**MOTOR COACH
INDUSTRIES**

SUBJECT: SAFETY RECALL OF DOGA WINDSHIELD WIPER MOTORS

Service Bulletin No. 344C

MODEL E / J Series Coaches	TYPE Field Change Program	SECTION/GROUP 3–Body	DATE Feb. 25, 2011
SUBJECT DOGA WINDSHIELD WIPER MOTOR			
CONDITIONS

Figure 2. Relay Installation

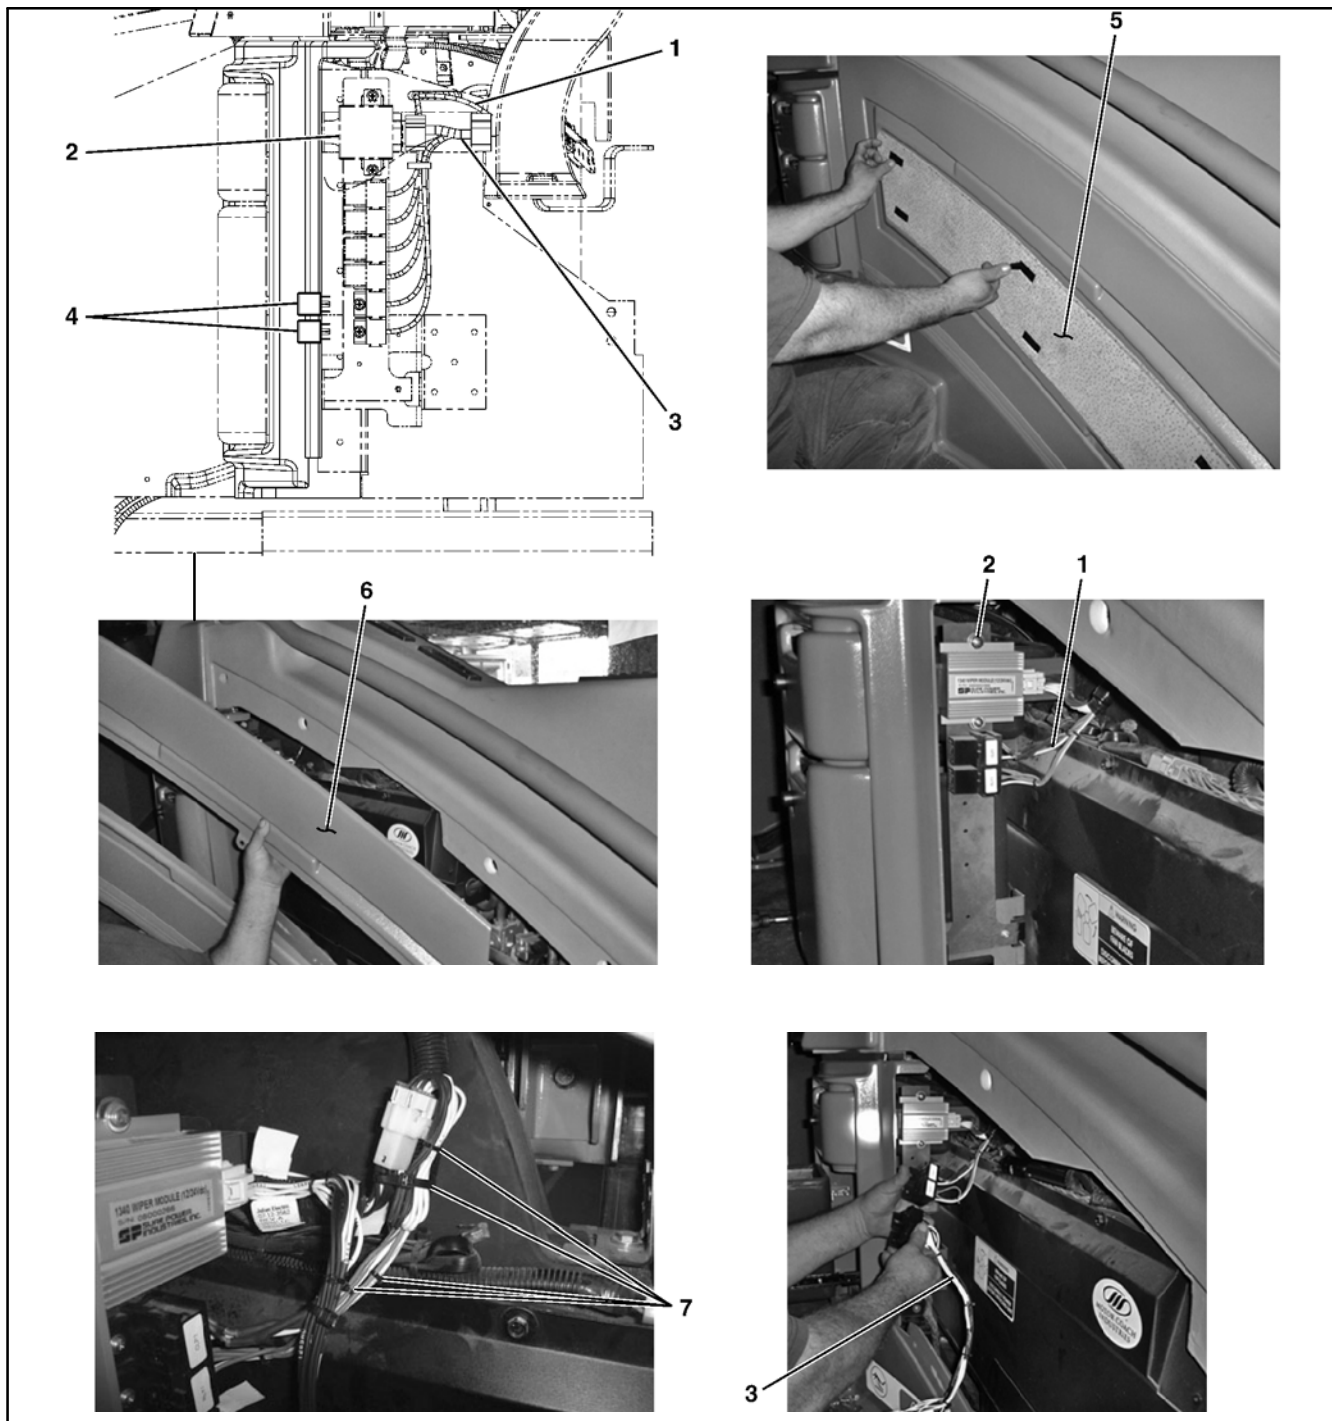
8. Remove the fabric return air panel and the return air panel (refer to Figure 2).
9. Locate dash harness Plug X145 (J1R). Unplug Plug X145 (J1R) from the wiper controller (refer to Figure 2).
10. Connect the male adapter P145B of the wiper controller adapter harness, p/n 07-12-3664 to Plug X145 (J1R) of the dash harness.
11. Connect the female adapter P145A of the wiper controller adapter harness, p/n 07-12-3664 to the wiper controller. Secure to dash harness using tyrap, p/n 19-11-258.
12. Using the screw, p/n 19-1-696 and washer, p/n 19-2-7, install the relay base section of the wiper controller adapter harness. Install the two relays, p/n 7L-5-79, into the relay base.
13. Using the hardware removed in Step 8, secure the fabric return air panel and the return air panel. Proceed to the front of the coach.

Figure 6. Rear View of Wiper Motor Installation

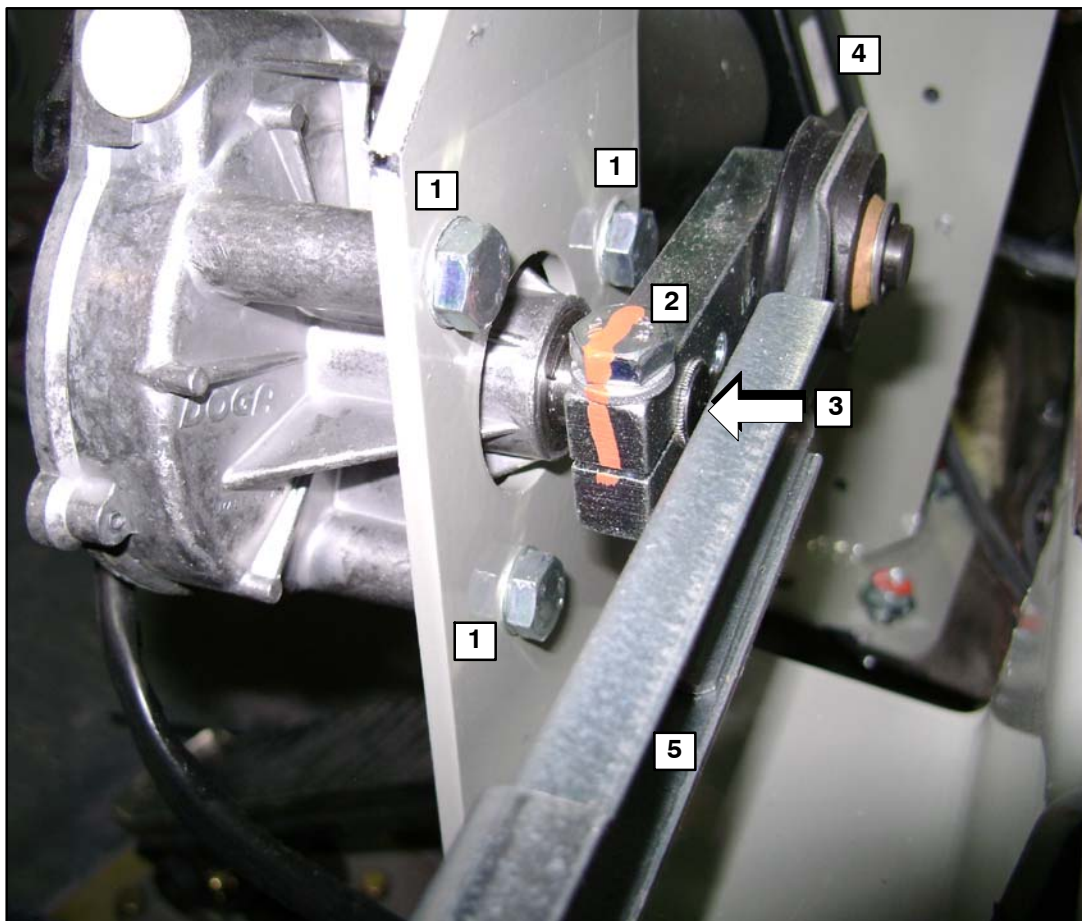
19. Locate the three wiper motor mounting bolts securing the wiper motor to the bracket (refer to Figure 6).
20. Loosen the wiper motor crank nut (refer to Figure 6).
21. Carefully push the linkage off the wiper motor shaft, Figure 6, ensuring no damage to the splines.
22. Using a 1/2" wrench or socket, remove and retain the three wiper motor mounting bolts (refer to Figure 6). Remove and discard the wiper motor.

33. Install the new wiper motor, p/n 03-34-1193, using the three wiper motor mounting bolts removed in Step 22. Secure the wiper motor to the bracket. Torque the motor mounting bolts to 15 to 18 ft.-lb.

37. Align the wiper motor linkage with the main wiper linkage and mount it on the motor shaft. Torque the wiper motor crank nut to 16 to 20 ft–lb. Apply torque seal from the face of the capscrew to the face of the wiper motor crank.

Figure 12.

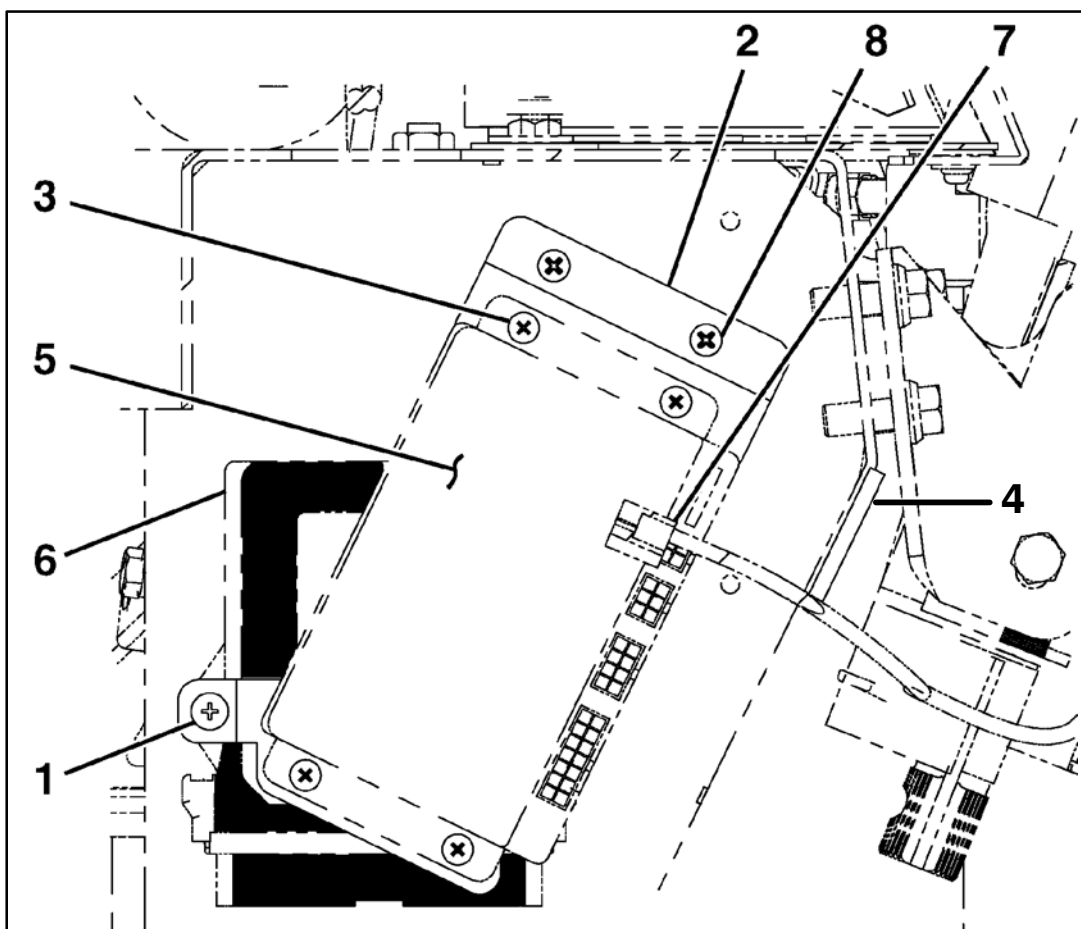
30. Remove and discard the existing screws that mount the pocket gateway to the steering column bracket. Using screws, p/n 19-1-583, and the existing pocket gateway mounting holes, mount the bottom bracket, p/n 07-08-3732, on top of the pocket gateway onto the LH (roadside) of the steering column bracket (refer to Figure 12).
31. Install the VIP controller as shown in Figures 11 and 12. Re-connect the wiper motor harness. Re-connect the harnesses to the VIP controller, and , if applicable, the steer angle sensor (SAS) connector.

32. Cut to length and install trimlock, p/n 21-7201-10, on bracket edge as shown in Figure 12.

Figure 13. Wiper Arms Before and After Linkage Adjustment

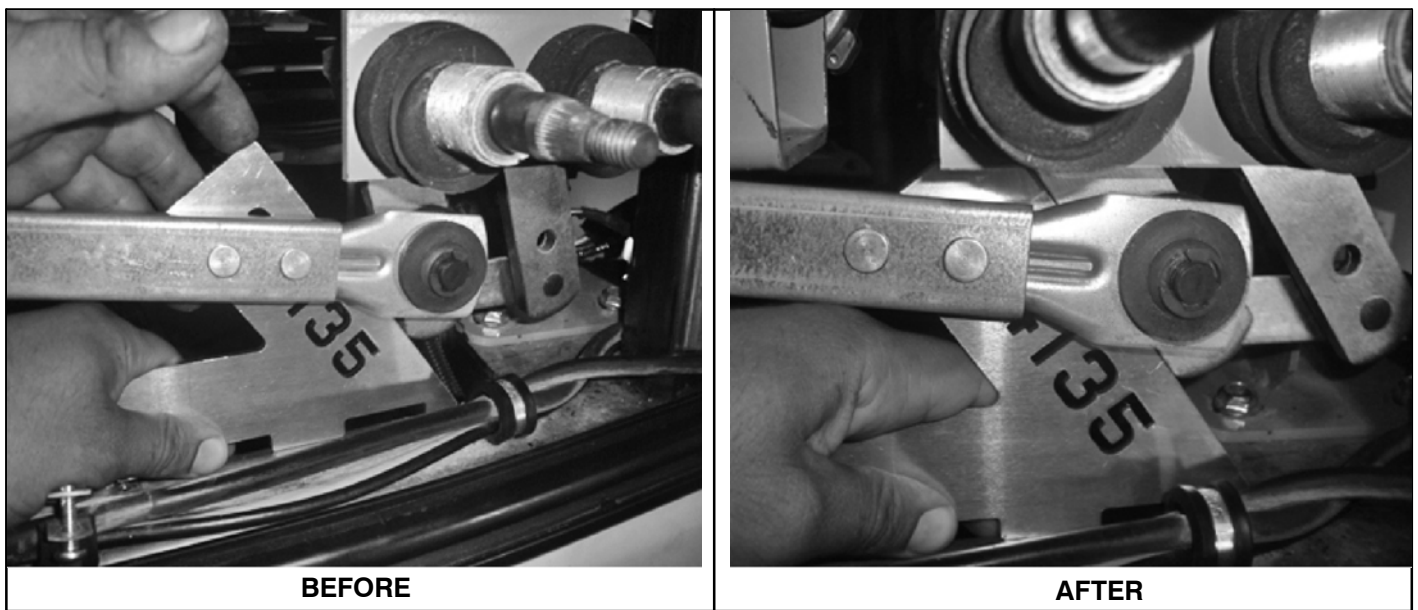
38. Positioned in front of the coach, locate the main wiper linkages (refer to Figure 13).
39. Verify that the arm swing angle from the wiper arm pivot is 35 degrees on both sides vertical by utilizing a gauge. With gauge tool 24135 ensure the angle measured from the frame member is 55 (+/- 1.0) degrees (refer to Figure 13). Repeat on opposite side of coach.

If the angle measured from the frame member is not 55 (+/- 1.0) degrees on both the curbside and roadside wiper arms as shown in Figure 13, proceed to Step 40.

If the angle measured from the frame member is 55 (+/- 1.0) degrees on both the curbside and roadside wiper arms as shown in Figure 13, proceed to Step 41.

40. Locate the wiper arm linkage sliding channel. Loosen the bolts on the sliding channel and adjust the linkage to achieve the 55 degree angle. Tighten bolts. Using the gauge, ensure the linkage is 55 degrees. Torque bolts to 16–18 ft–lb.

Figure 18. Front junction box and drag link compartments.

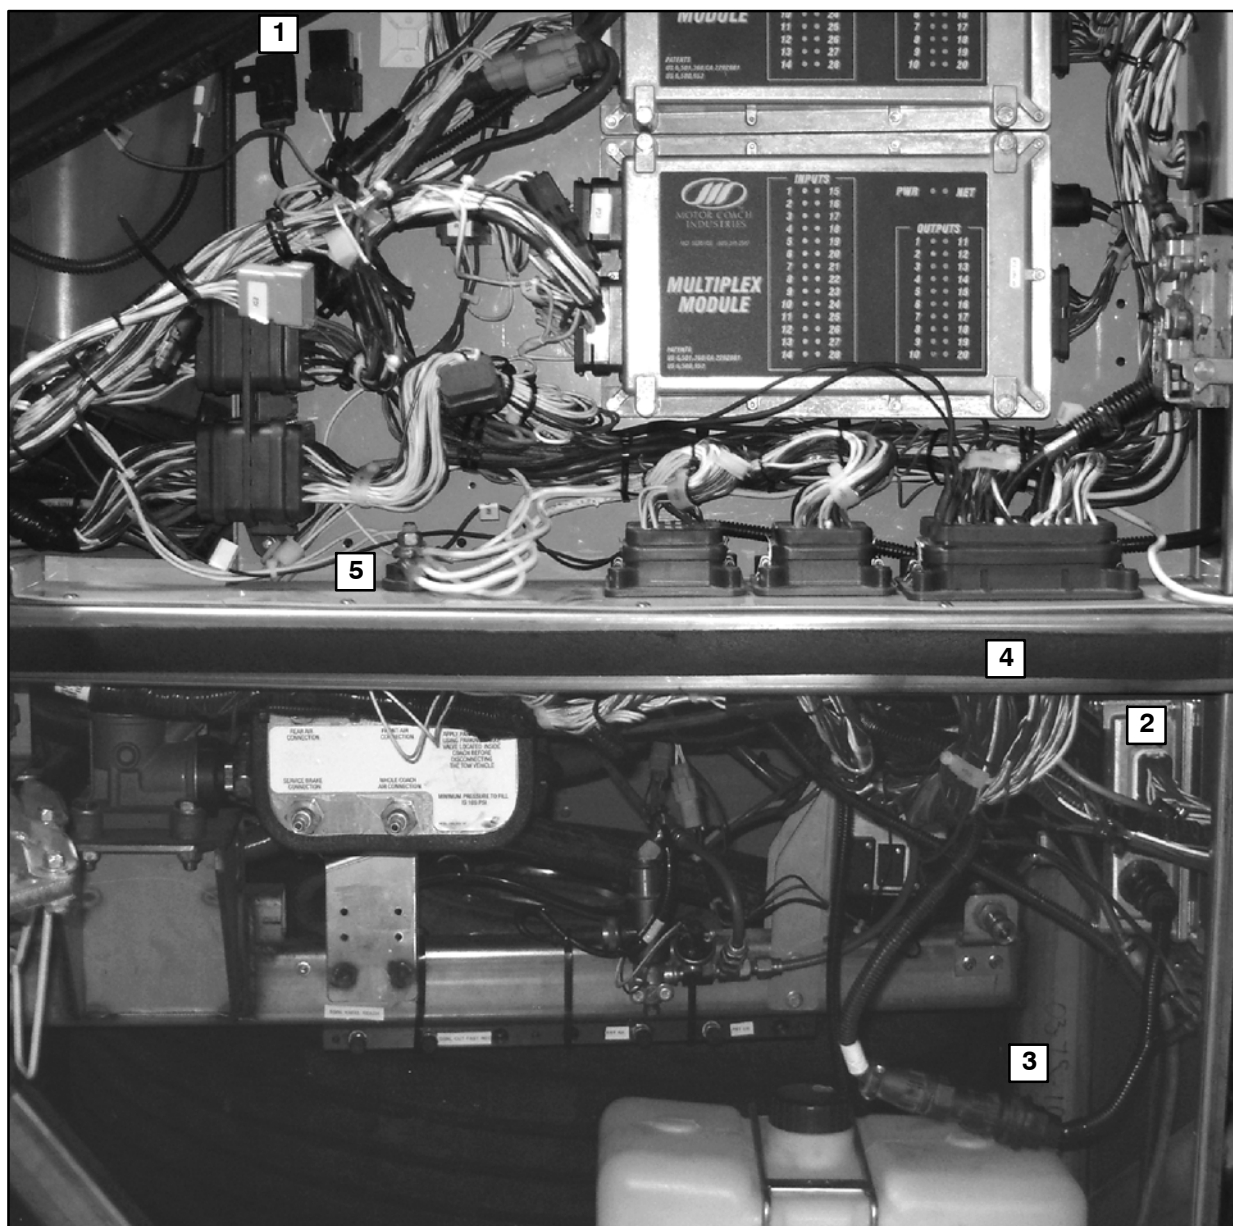
52. Connect ring terminal of wire 12441 onto Ground stud in the front junction box (refer to Figure 18).

Figure 20.

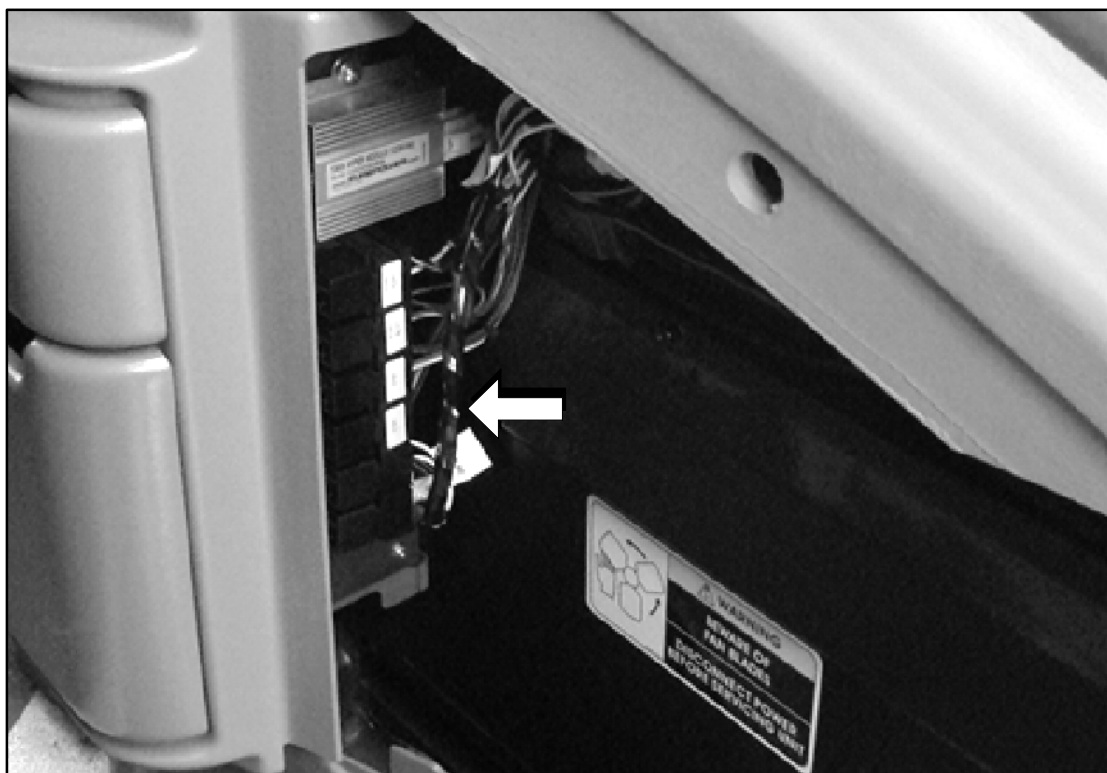
61. Above the cabin entrance stepwell, release the six (6) fasteners and remove the return air access panel. Remove the return air panel (refer to Figure 20).
62. Locate wires WM5AAA and WM6AA on Pin H and K of Plug 145A on the existing wiper control adapter harness (utilized with the model 259 motor) (refer to Figure 20). Using wire cutters, cut off the end of wire WM5AAA connected on the splice. Cover the exposed end of the wire splice with electrical tape. Using wire strippers, expose 0.50 inch of wire on wires WM5AAA and WM6AA. Slide the heatshrink, p/n 19-11-1465, and solder splice, p/n 19-11-1466 over wire WM5AAA. Align the exposed wire ends of WM5AAA and WM6AA. Crimp in the center to secure. Solder the wires together using p/n 21-8207-7. Cover the solder joint with the heatshrink, and apply heat.
